REMARKS

Drawing Objections

FIG. 5

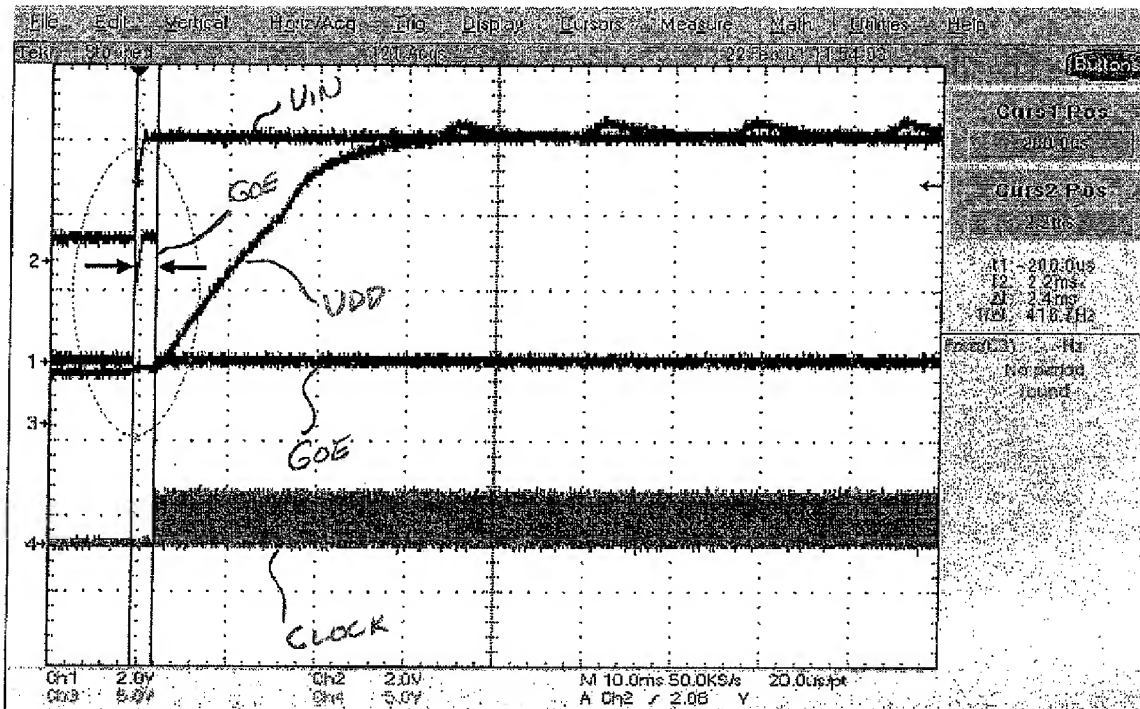
The Examiner objected to Figures 5, 6, 8, and 9 arguing that they are captures of a digital oscilloscope making it difficult to differentiate between the signals. However, digital oscilloscopes are commonly used, and one of ordinary skill in the art would be able to look at the oscilloscope captures and differentiate between the signals. Also, references pointing out the specific signals aid in the differentiation of the signals. Figures 5 and 8 were objected to for not providing any references. Replacement Sheets are attached to address the objection.

ADDING REFERENCES : VIN, GOE, VDD, and CLOCK

FIG. 8

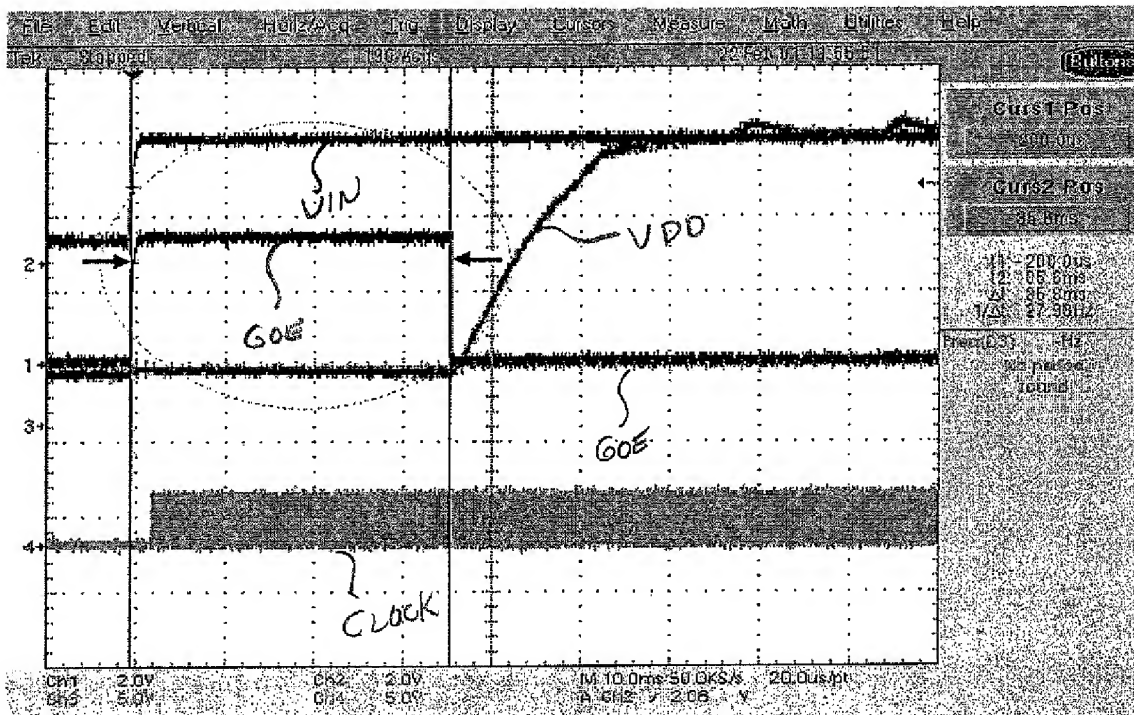
ADDING REFERENCES: VIN, GOE, VDD, GOE, CLOCK
